Re: Notice of Alteration – Glenboro, MB – License 1712 RR

Crop Production Services (Canada) Inc.
Glenboro, MB

Changes Within the Development

A site plan showing the additions and deletions in red has been attached for Manitoba Conservation's files.

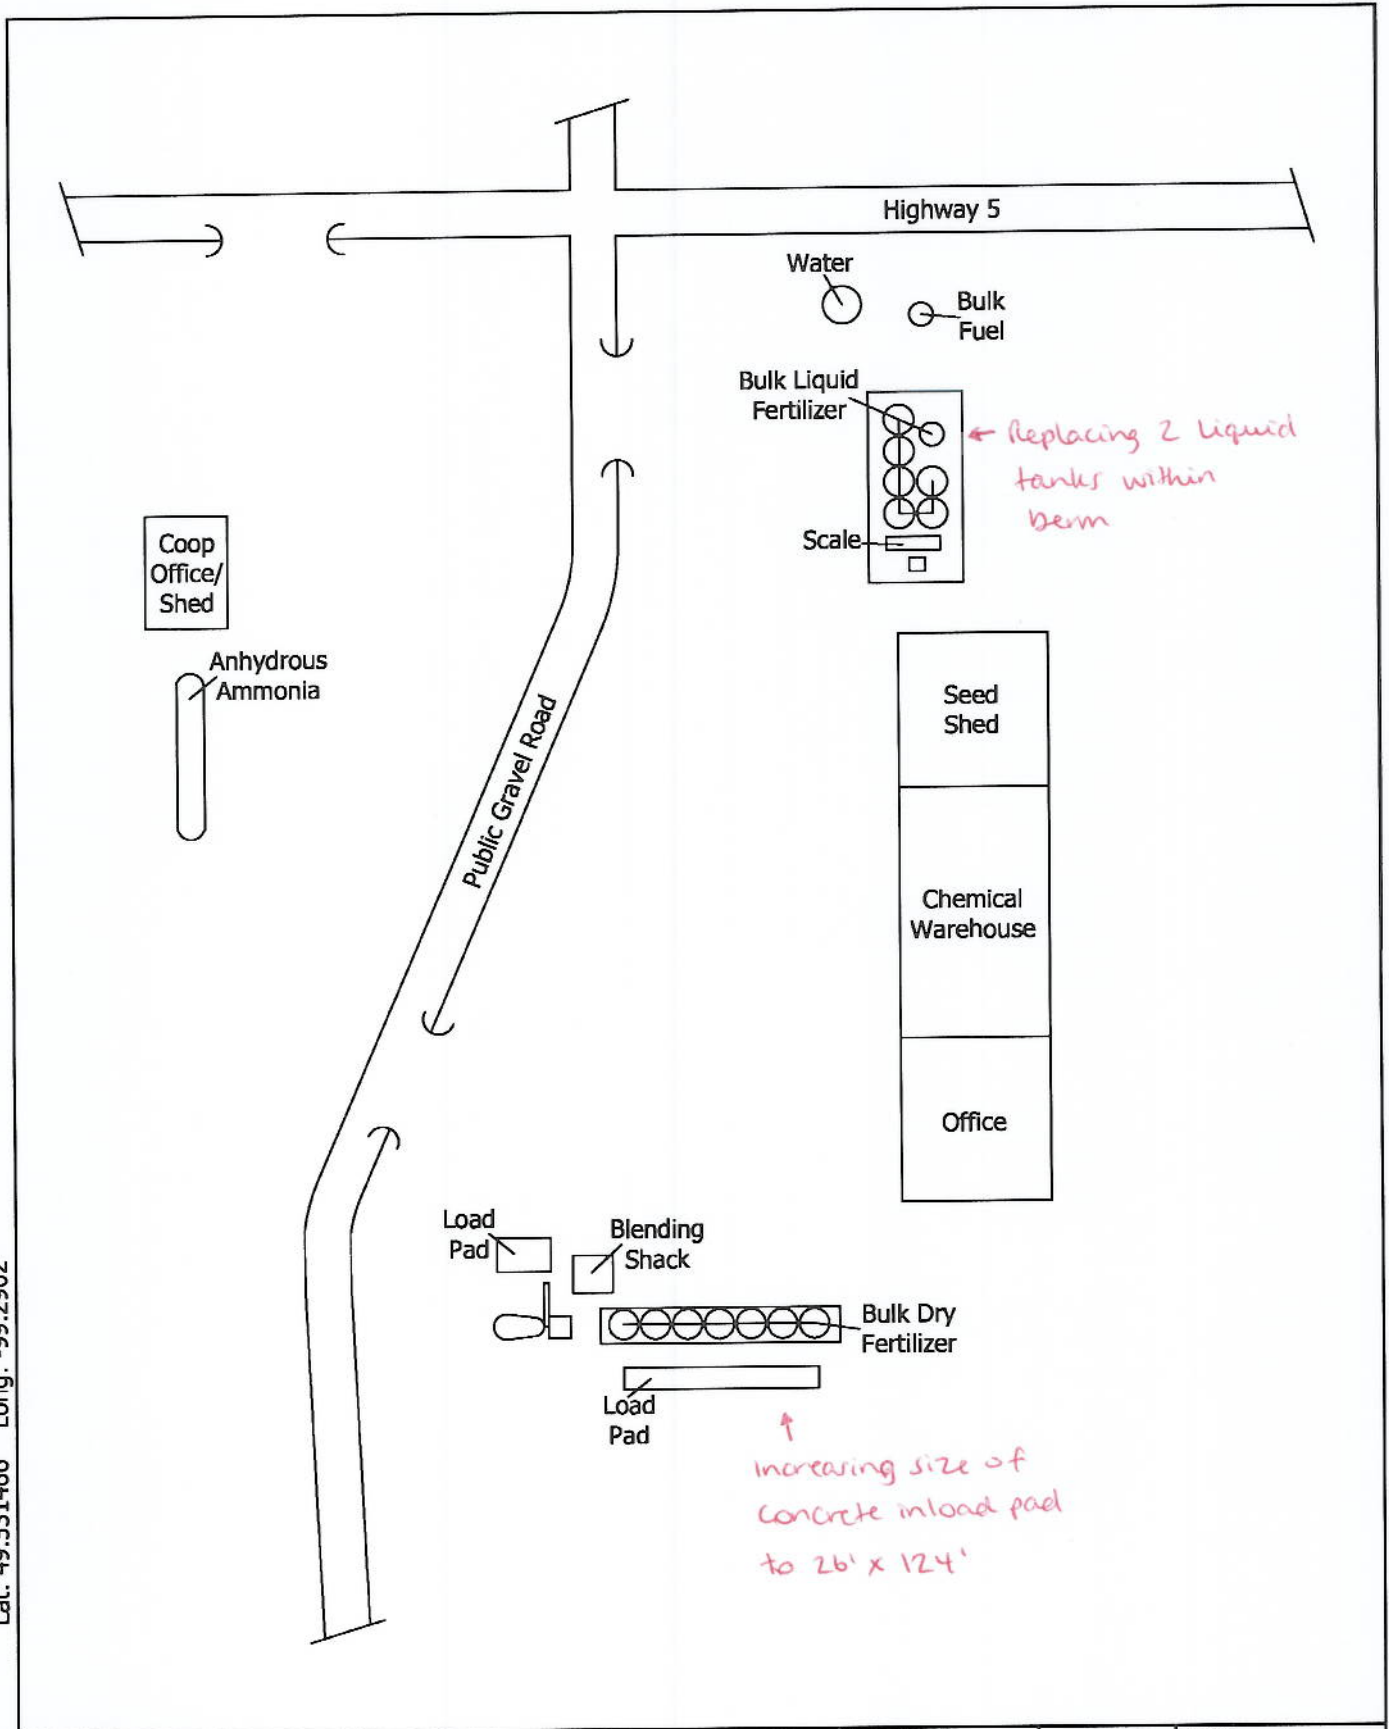
At this time, CPSC would like to notify Manitoba Conservation that it intends to replace the two 90 tonne metal tanks with two 200 tonne Novid stainless steel tanks.

Also, at this time CPSC would like to notify Manitoba Conservation that it intends to increase the current concrete inload pad (16' x 112') for the dry fertilizer plant to 26' x 124'.

Total available liquid fertilizer storage will increase from 590 tonne to 810 tonne.

With the increase in capacity, no significant changes in the environmental effects are anticipated from the alteration of this development. While we are increasing the size of the largest tank on site, the containment berm was sized to contain a potential leak from the largest tank plus 25 percent.
